SUBJECT: REQUEST FOR ADDITIONAL INFORMATION REGARDING CENPD-137,  
SUPPLEMENT 2-P

## REQUEST FOR ADDITIONAL INFORMATION CENPD-137, Supplement 2-P

**Subject:** Supplementary Information to FTI's Response to NRC's Request for Additional Information on BAW-10168, Volume II, Revision 2, October 1992; RSG LOCA - BWNT Loss-of-Coolant Accident Evaluation Model for Recirculating Steam Generator Plants.

# CORE VOID DISTRIBUTION - 3 in Break

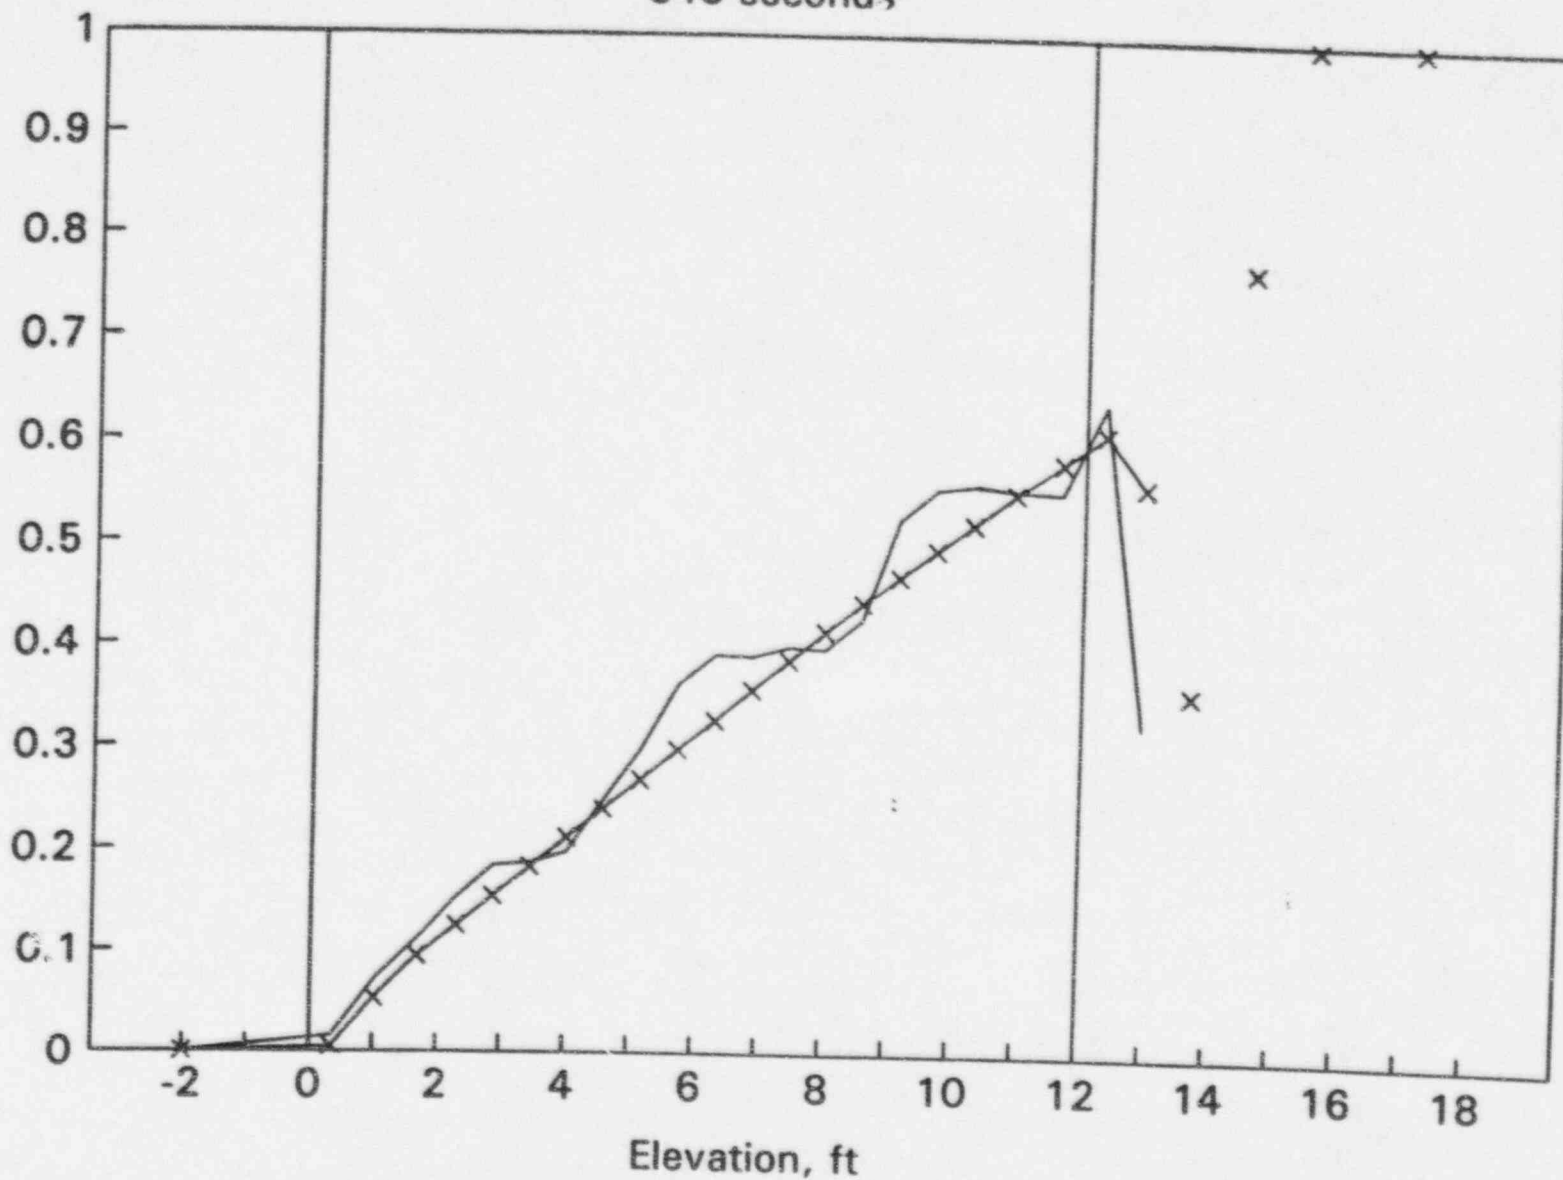
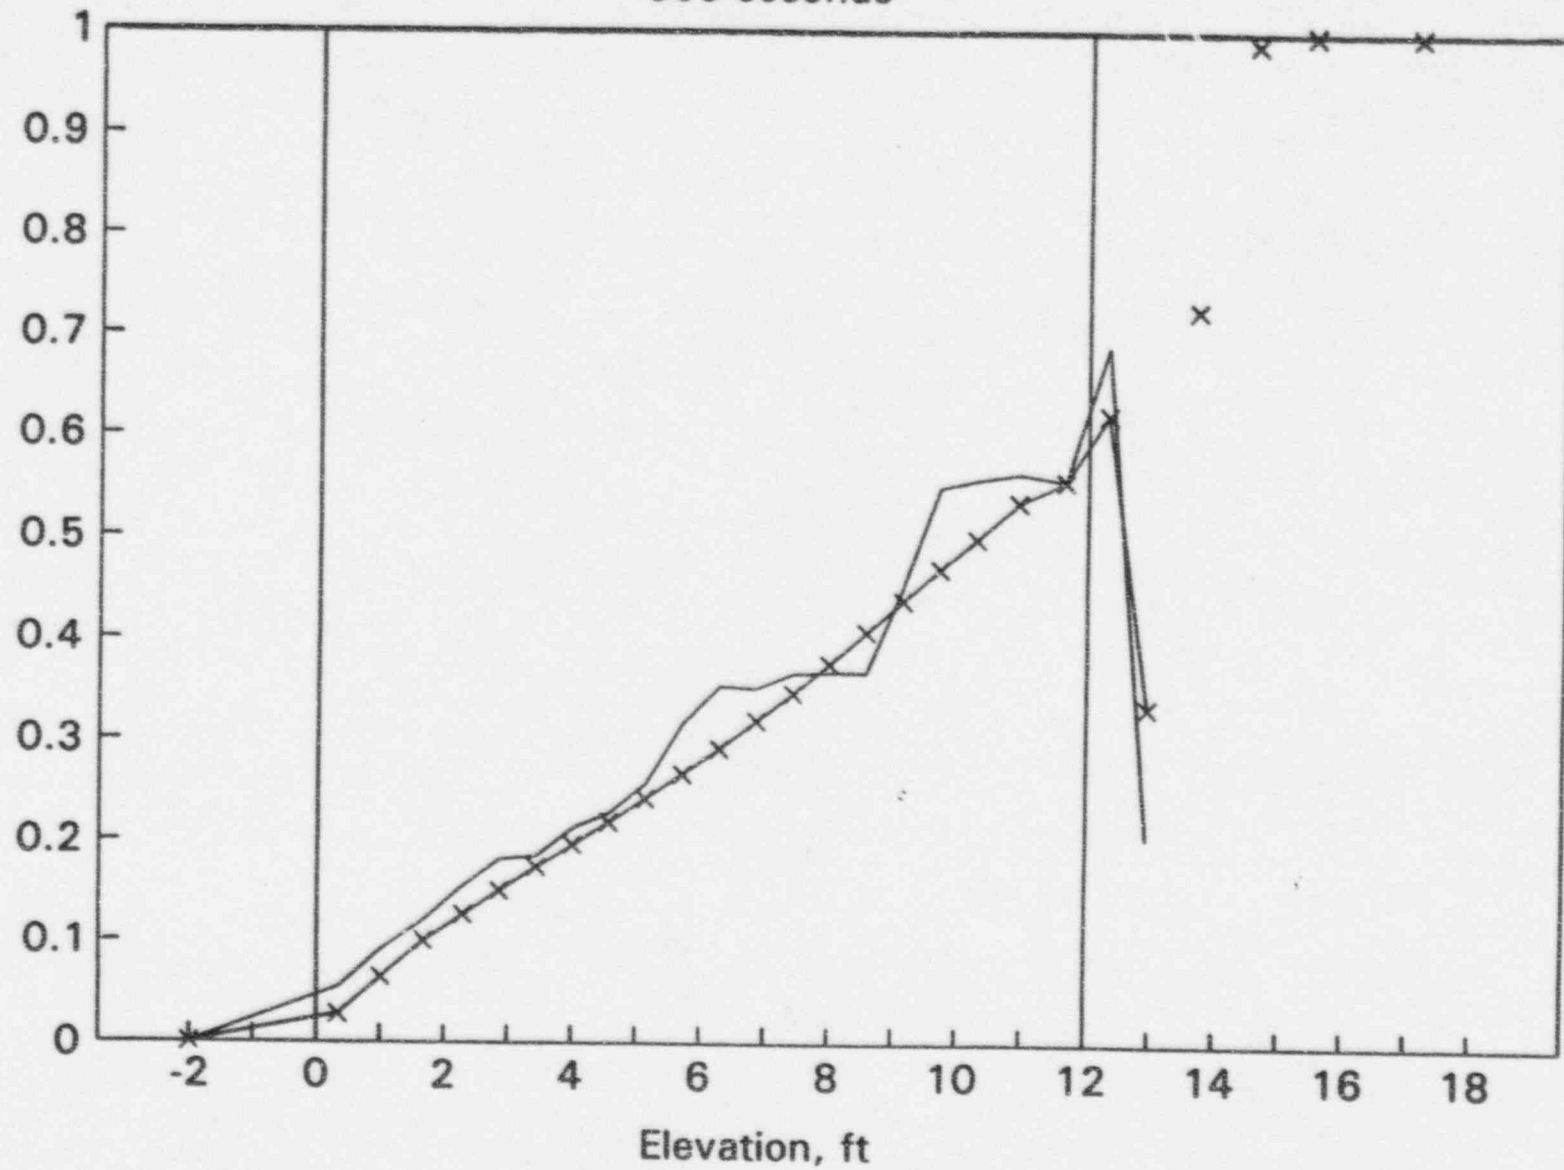
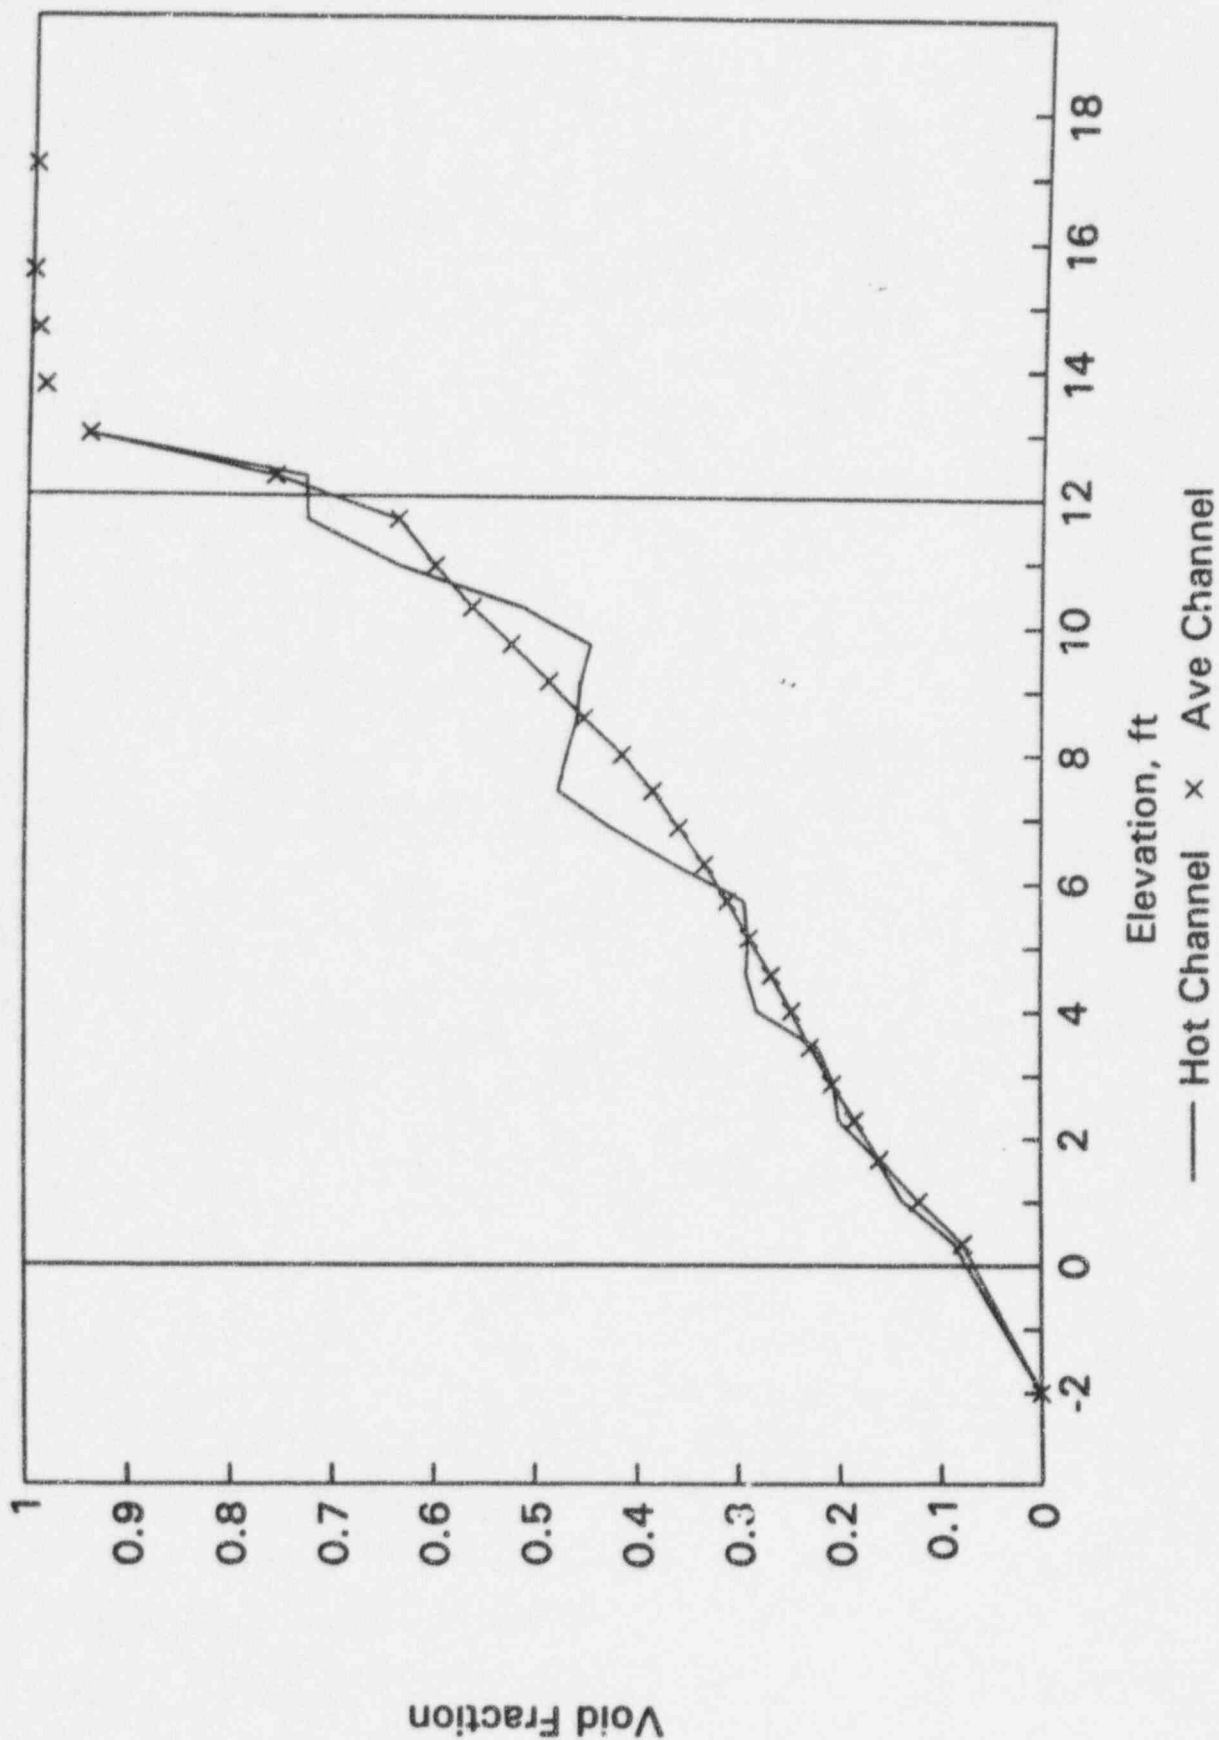
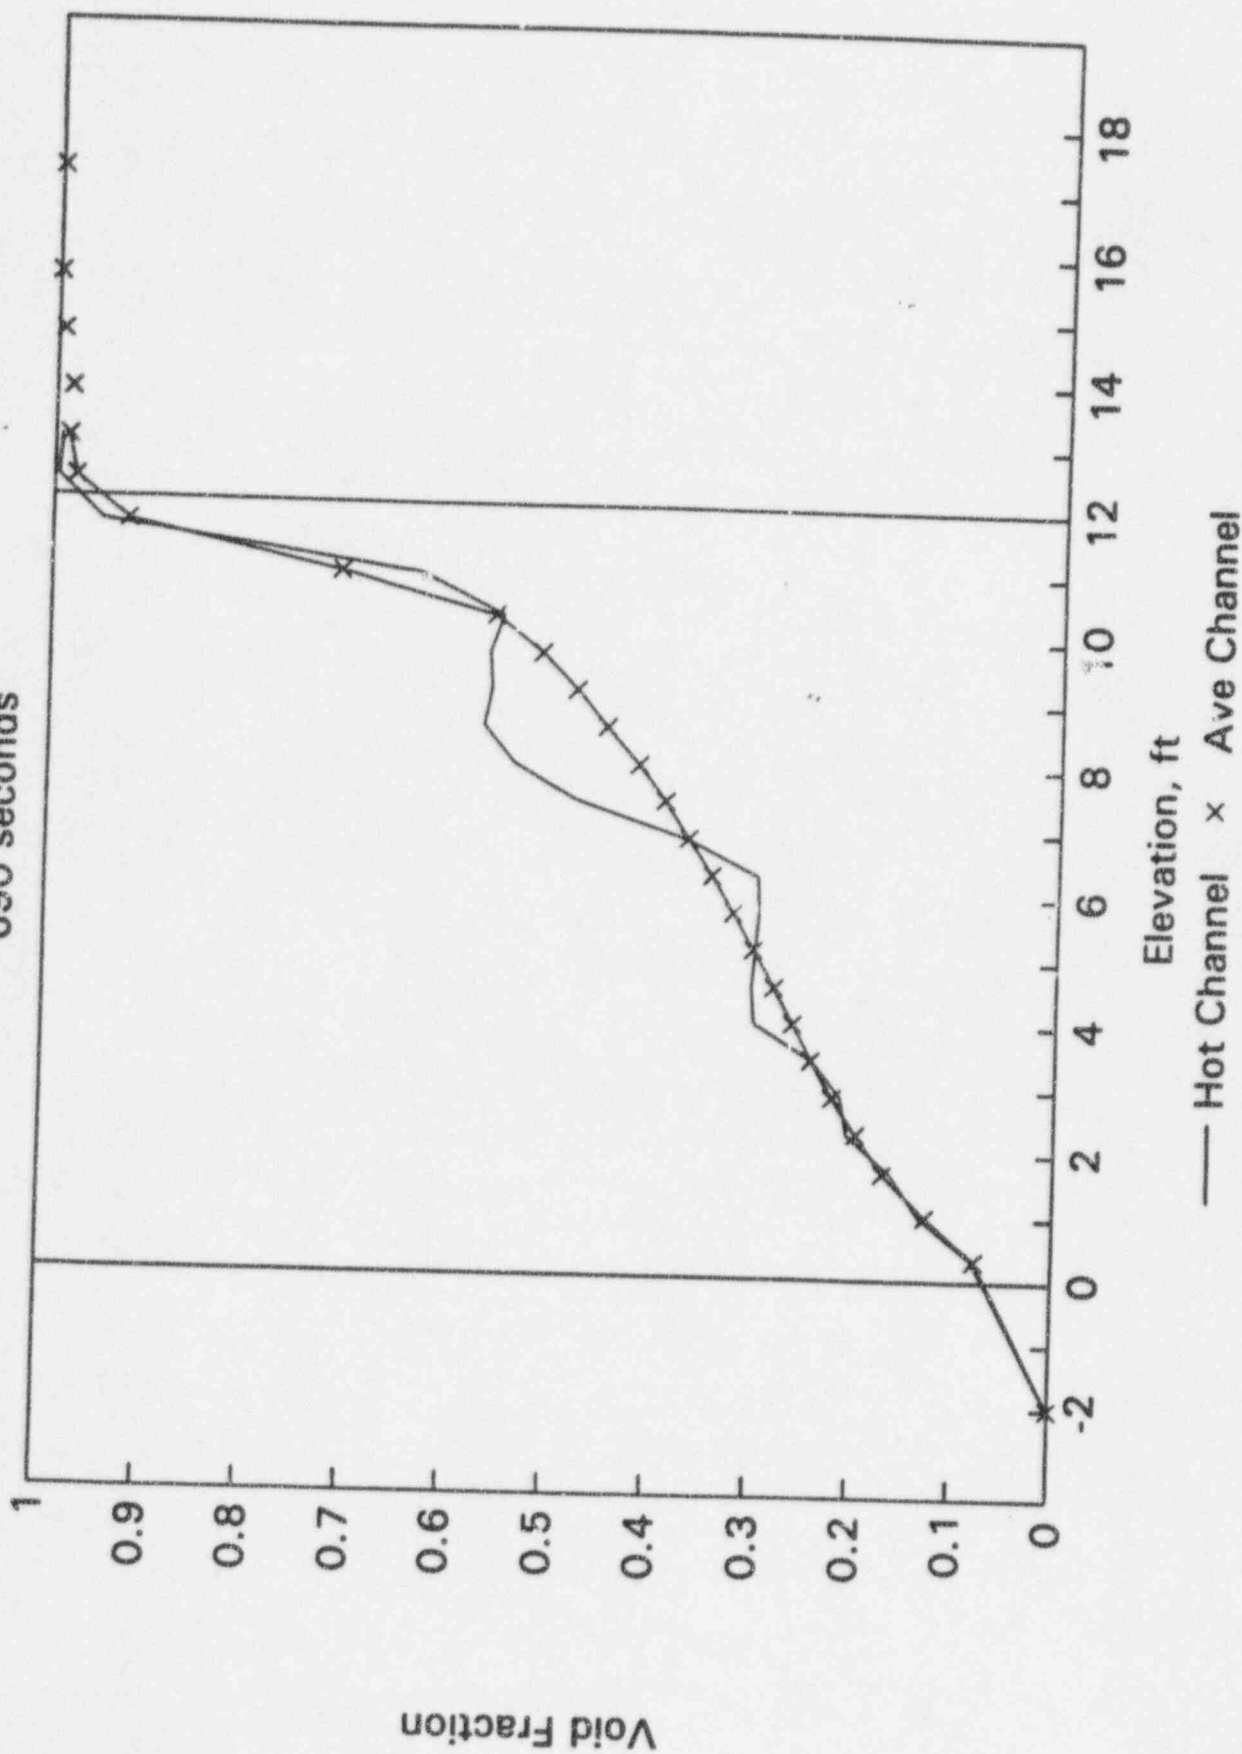
That the hot channel and average channel mixture heights evolve reasonably during a core uncover can be observed in the attached figures. These figures display the axial void distributions of the hot and average channels as they developed for a 3-inch pump discharge break in a Westinghouse-designed 4-loop plant over the loop seal clearing period. The figures display void fraction versus axial core elevation from the lower plenum to the upper plenum at the elevation of the outlet nozzles. Each void fraction is displayed axially at the center of the volume from which it is taken and is connected to the void fraction of the adjacent nodes by a straight line. If not recognized, this technique can introduce some confusion, as occurs between the lower plenum and the core. The lower plenum is or is nearly liquid solid throughout the time period of these graphs, but the linear connection to the first core volume, which is legitimately voided, produces a visual impression that the lower plenum contains steam as the bottom of the core is approached. In truth there is a step change in void content between the lower plenum and the core. The same recognition should be made in reviewing the upper plenum void fractions. This, in part, is the reason that the channels, except for the lower plenum to the core, are displayed with connecting lines while the upper plenum volumes are displayed as points. The time at which the figure is captured is displayed just above the figure border. Within the upper plenum, the upper most value is at the elevation of the center of the core outlet nozzles. This volume spans the height of the outlet nozzles. The next lower volume is entirely below the span of the hot leg piping.

Loop seal clearing for the case shown in the figures occurs at approximately 715 seconds. The graphs display the core elevation head/mixture height as the necessary head to clear the loop seal develops on the approach to loop seal clearing and as the core refills after clearing. Graphs are provided at 640, 660, 680, 690, 700, 710, 715, 720, and 800 seconds. By 640 seconds, the clearing process has initiated and the core mixture level has fallen below the nozzle belt as indicated by the void fraction in the upper most volumes. (The upper volume represents the portion of the upper plenum adjacent to the outlet nozzles.) The core is still covered with mixture and the depressed void fraction at the exit to the hot channel can be observed. It can also be

observed that the correspondence in void content between the average channel and the hot channel is quite good. Deviations occur, but the general trend is a slightly higher void content in the hot channel. There is no indication that the lower void content of the hot channel exit volume has propagated downward. By 660 seconds, more of the upper plenum is voided, but the core is still covered and the core void distributions remain reasonable. At 680 seconds, the columns representing the hot and average channels are starting to void. The upper plenum is essentially 100 percent voided. The core heated regions are still covered since the high voiding has not penetrated below the non-heated regions of the fuel assemblies. By this time, before any core heatup, the void fraction for the hot assembly upper region has evolved into agreement with that of the average channel. At 690 seconds, the heated regions of the hot and average channels have started to uncover. Loop seal clearing is now about 25 seconds away. Because the core outlet void fraction is at 90 percent, the cladding temperatures remain near saturation.

At 700 seconds, the two upper volumes of the heated core are showing substantial voiding and the very top heated node may be experiencing some heatup. For the limited uncover apparent here, mist entrainment from the mixture may be sufficient to prevent core heatup. The hot and average mixture levels are in agreement as the uncover proceeds. At 710 seconds, the mixture has fallen to its lowest level during loop seal clearing. The hot and average channel mixture levels remain in agreement with the hot channel slightly more voided. At 715 seconds, the loop seal for the broken loop has cleared and the downcomer and core levels are starting to equilibrate creating a core refill. By 720 seconds, the refill has progressed into the upper plenum. The void fraction at the very outlet of the hot channel is again depressed but that was not observed in the partial refill at 715 seconds. Thus, the predictions of the hot channel exit void fraction are consistent with the needs of the transient prediction, attaining the required degree of accuracy under conditions when core uncover is occurring or eminent. By 800 seconds, the refill is complete and the core boil down phase has been entered. As shown, the refill did not completely fill the vessel. The region just below the out nozzle remains at an elevated void content and the upper plenum at the outlet nozzle elevation is completely voided.

In conclusion, core modeling has been arranged to provide for hot and average channel effects. Specific provisions have been incorporated into the EM to achieve conservative predictions of cladding temperature (crossflow resistance for the upper half of the core). The modeling works well during core uncover as evidenced by the agreement between the hot and average channel mixture levels. Although a modeling factor does lead to an apparently inconsistent void fraction in an upper unheated volume of the hot channel during those phases of the SBLOCA transient when the upper plenum contains mixture, this difficulty is resolved as the core uncovers and is not present at any time that the calculation is predicting core uncover or calculating cladding temperature excursions. Therefore, the core modeling approach employed is appropriate for the calculation of small break LOCA simulations.
